TECHNICAL BULLETIN — February 2015

387. Huss Enterprise/UFO central hub and boom cracking

Service-Information 05-02

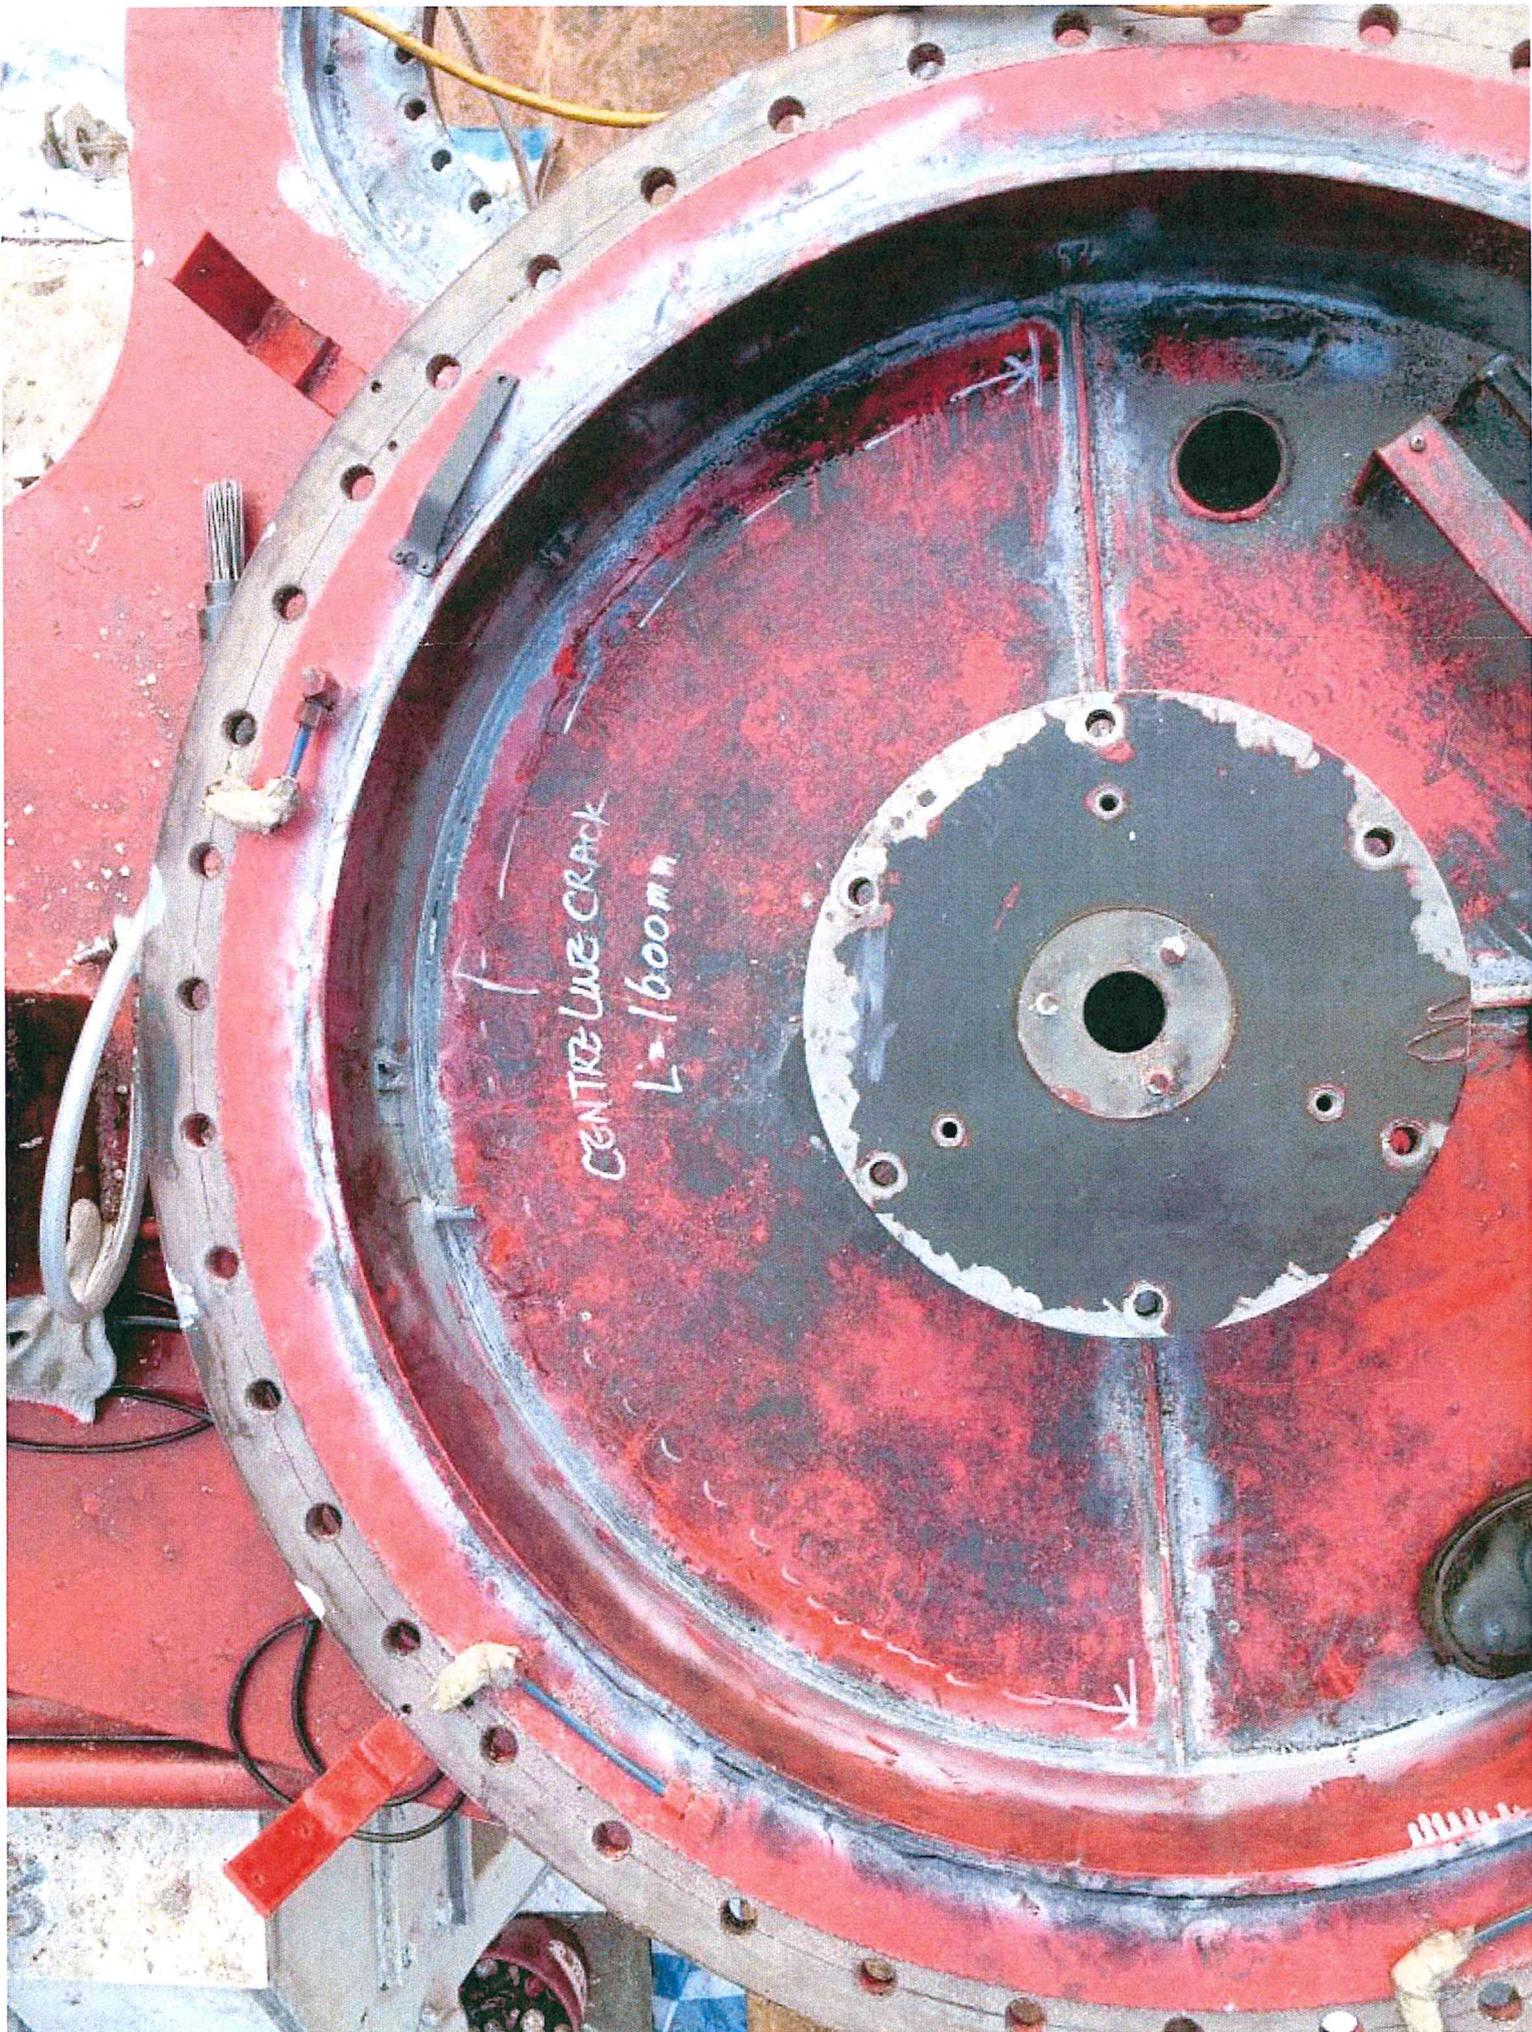
During a general overhaul of an Enterprise ride, cracks in the area of the boom head have been detected.

CENTRE LINE CRACK
L = 1600mm

It is strongly recommended to get this area inspected by a certified company.
